BCA COMPLIANCE ASSESSEMENT REPORT

465-469 Princes Highway, Rockdale NSW 2216

**Proposed mixed use (commercial/residential)
building with associated basement level car parking**

Report Number	A24_275_BCA	
Revision Number	Stage	Date of Issue
01	Issue for DA – draft	29.07.2024
02	Issue for DA	25.09.2024

<p>Construction of sanitary compartments</p> 
s)	<p><i>Room Heights (Part F5)</i></p> <p>Room heights to be detailed on CC plans (generally 2.4m required for habitable areas and 2.1m for non-habitable areas)</p>

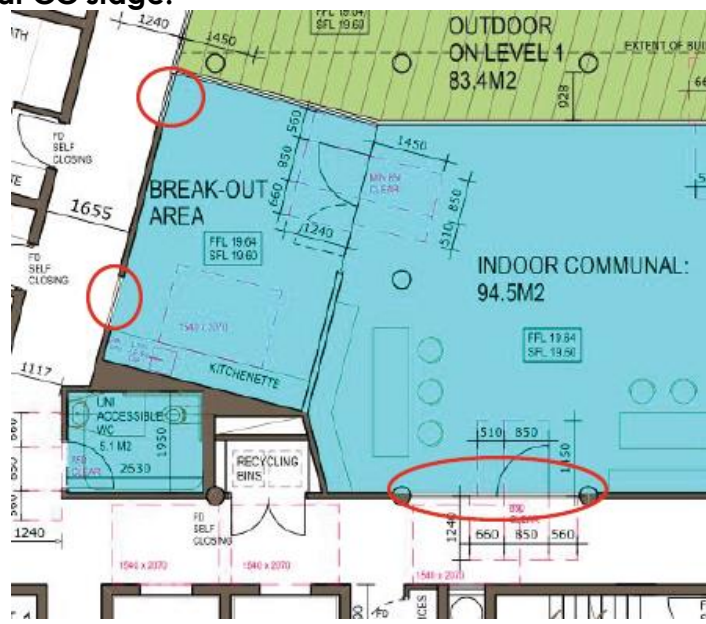
r)	<p><i>Sanitary facilities (Part F4)</i></p> <p>Facilities must be provided as per F4D2 –Sufficient space should be allowed for facilities for the commercial/retail tenancies (noting that accessible facilities are typically required for each)</p> <p>Note under F4D8 0 where a 1.2m clear space is not provided to inwards swinging WC doors, lift off hinges will need to be provided.</p>

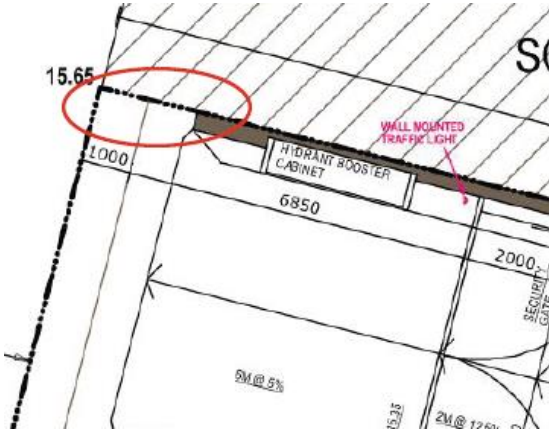
u)	<p><i>Sound transmission and insulation (Part F7)</i></p> <p>Acoustic separation is required between units and between units and other parts of the building. Specific design details required at CC stage.</p>
